### Development Assessment

**Subject:** DA2019/0309 – 257 Whale Beach Road, Whale Beach

**Record Number:** 2019/686357

**Figure 1.** Section through the proposed dwelling west to east demonstrating height (8.5m and 10m height limits) and slope of site.

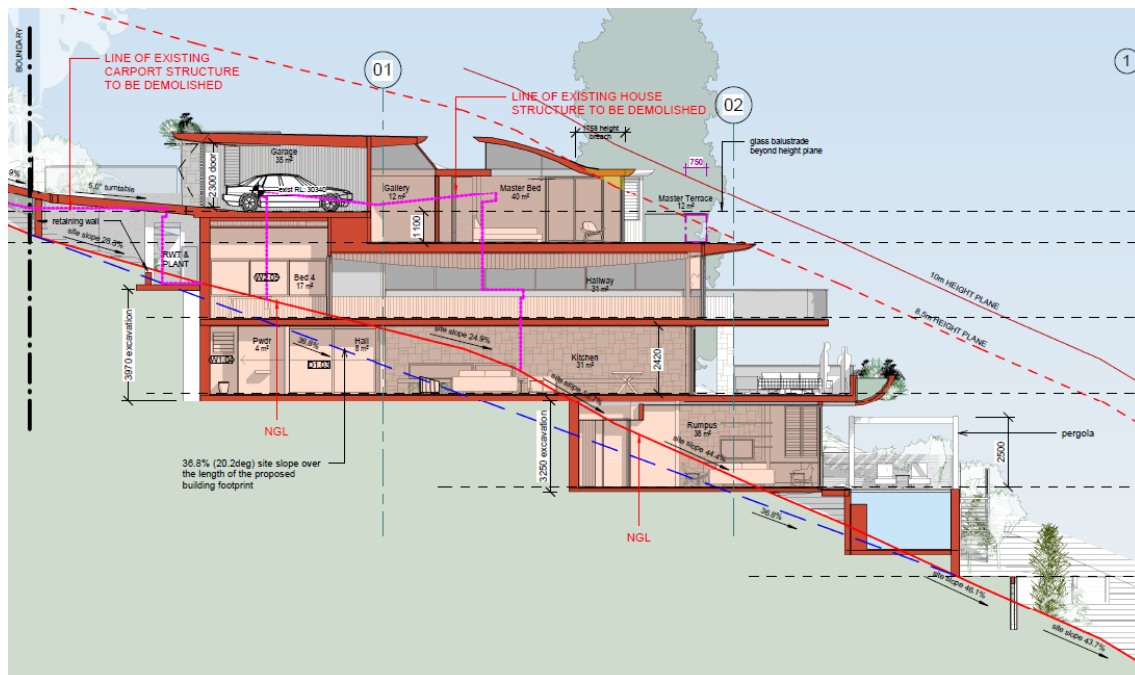
The building height of the proposed dwelling varies from 5.6m - 9.5m, which demonstrates compliance with the height of buildings (8.5m – 10m) given the slope of site being developed is greater 30% (Clause 4.3(2D)).

**Figure 2.** Rear section of the proposed development demonstrating the Foreshore Building Line (FBL) and the distance of FBL from the rear boundary (21m), the distance of the development from the rear boundary 28.7m and the distance of the development behind the FBL (7.7m).

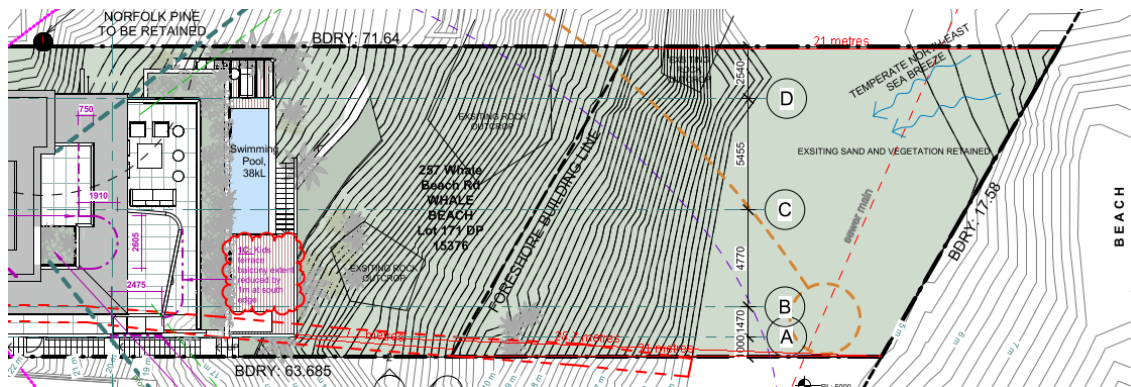
Development Standard	Requirement	Proposed	% Variation	Complies
Height of Buildings	8.5m - 10m*	5.6m -9.5m*	N/A	Yes
Foreshore Building Line (FBL)	FBL (21m west of rear boundary)	Outside FBL (7.7m behind FBL & 28.7m from rear boundary)	N/A	Yes
